Site Development Plan for Columbia Gateway, Parcel T-18 Proposed Two-Story Office Buildings A, B & C SDP 06-083 Eastridge at Columbia Gateway Howard County, Maryland

Revised 2
Cover Sheet
Columbia Gateway, Parcel T-18
Proposed Two-Story Office Buildings A, B & C
Eastridge at Columbia Gateway

Howard County, Maryland — Sheet 1 of 14
Scale: As Shown — August 2, 2006 — SDP 06-083

Proposed Layout 2

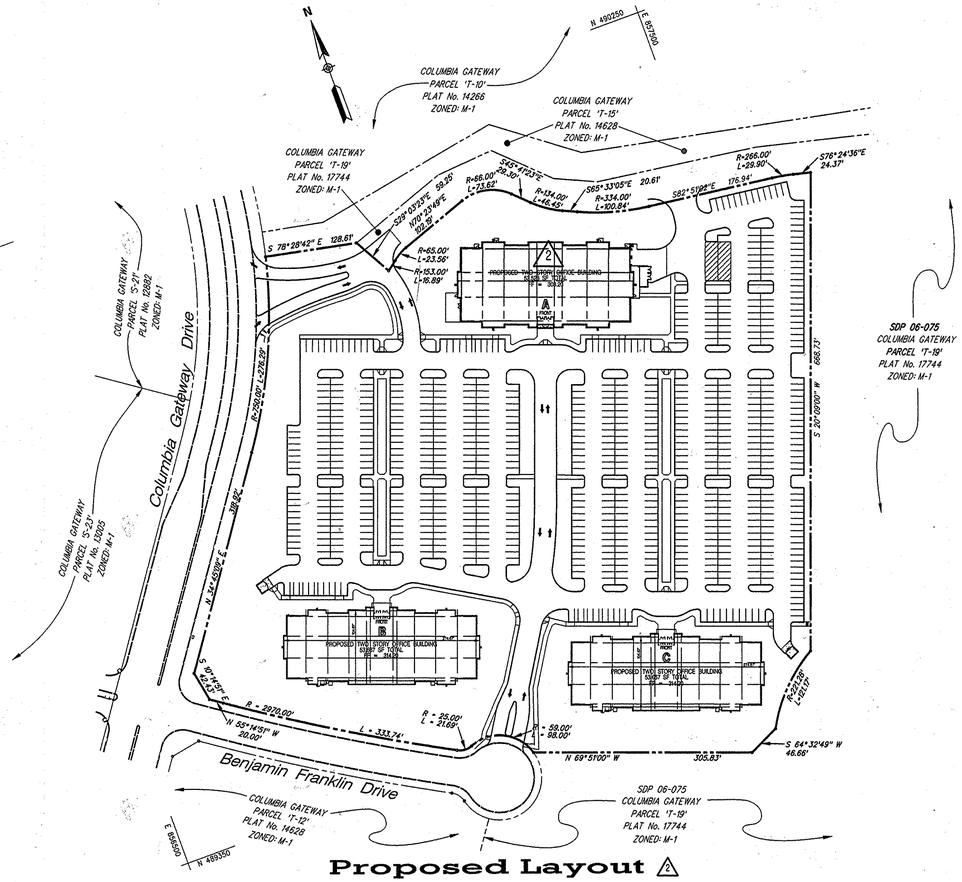
2 AUGUST 7, 2012
PROPOSED RED-LINE REVISON NO.2
REVISIONS TO THIS SHEET (FULL SHEET SUBSTITUTION)
REVISE FOOTPRINT BUILDING 'A' ON "PROPOSED LAYOUT"
REVISE SOUTH ELEVATION BUILDING 'A' "BUILDING HEIGHT PROFILES"
REVISE GENERAL DATA-AREA TABULATION-PARKING DATA "SITE ANALYSIS CHART"

Roof Drainage Detail Building A

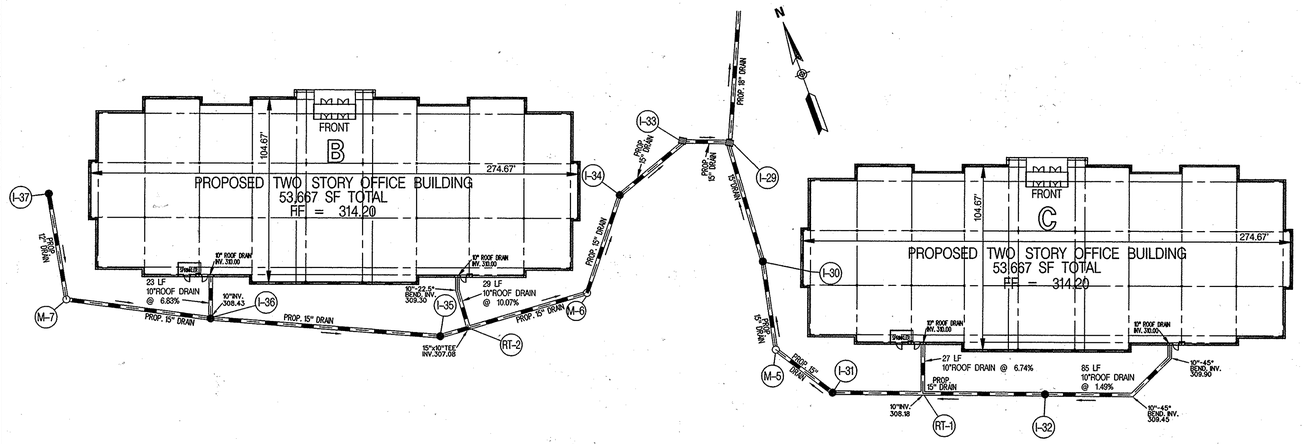
⚠3 8-7-12
PROPOSED RED-LINE REVISON NO.2 REVISIONS TO THIS SHEET ROOF DRAINAGE DETAIL DETAIL BLDG. A
"Professional Certification: I hereby certify that these documents were prepared or approved by me, and that I am a duly licensed professional engineer under the laws of the state of Maryland, License No. 18848, Expiration Date: 09-19-12."

2 Detail Handicap Parking and Accessible Route For Building A Scale: 1" = 20'

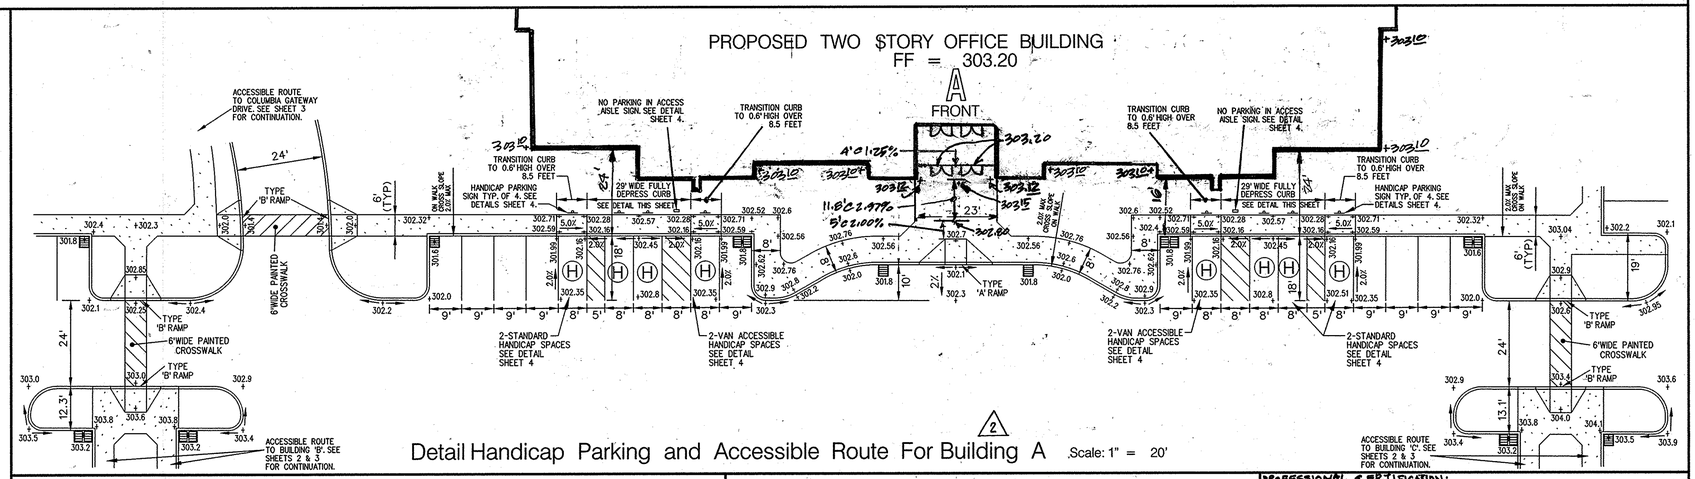
REVISIONS TO THIS SHEET
REVISE FOOTPRINT BUILDING A -ACCESSIBLE ROUTE DETAIL
REVISE PAVING LIMITS AND ADD CONCRETE PAVING DETAIL

BUILDING 'A' CONNECTION PRIVATE WATER PROFILE

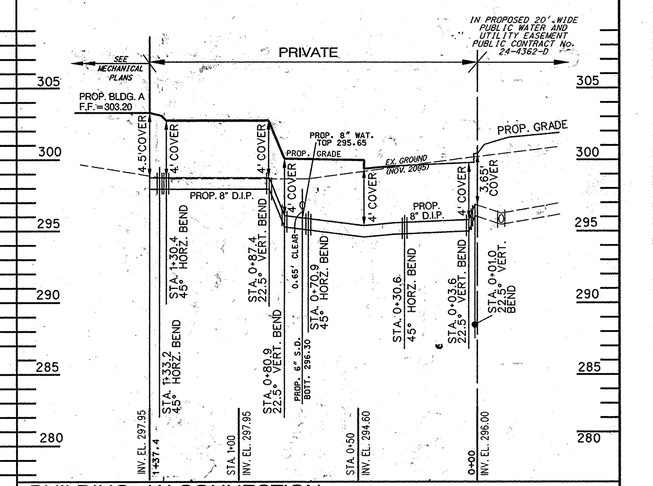
2 PROPOSED RED-LINE REVISON NO.2 8-7-12
REVISIONS TO THIS SHEET
REVISE PRIVATE WATER PROFILE -BUILDING A CONNECTION
ADD SANITARY SEWER MANHOLE S-4A. REVISE LOCATION OF C.O.#1-PRIVATE SANITARY SEWER PROFILE

PLAN

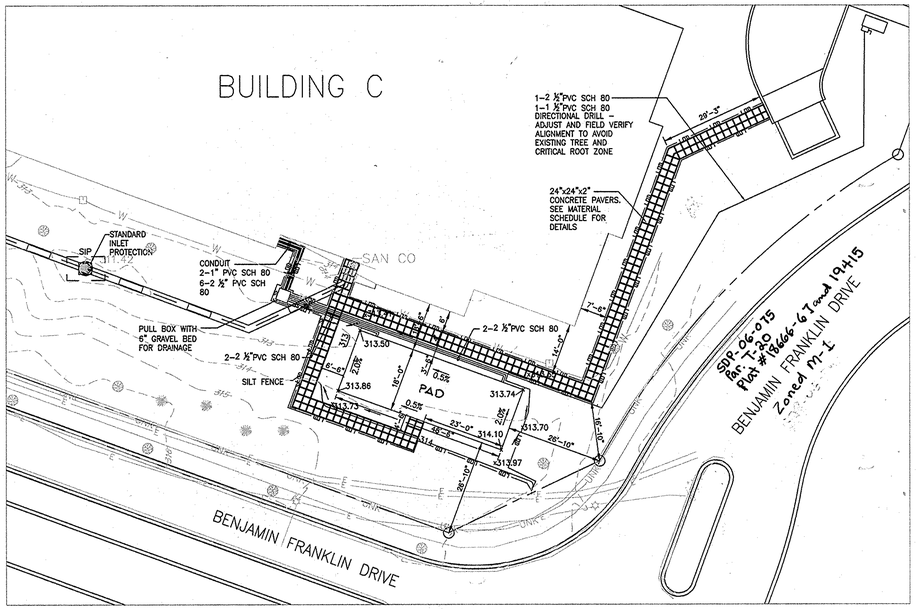
ADD CONCRETE PAD FOR GENERATOR AT SOUTH EAST CONNER OF BUILDING C.
THE PROPOSE WORK INCLUDE ADDITION STANDBY GENERATOR, AND ASSOCIATED CONDUIT, TO BACKUP ENTIRE BUILDING INCLUDING PAD, BRICK ENCLOSURE, AND POWER HOOK UP FOR ROLL UP TRAILER.
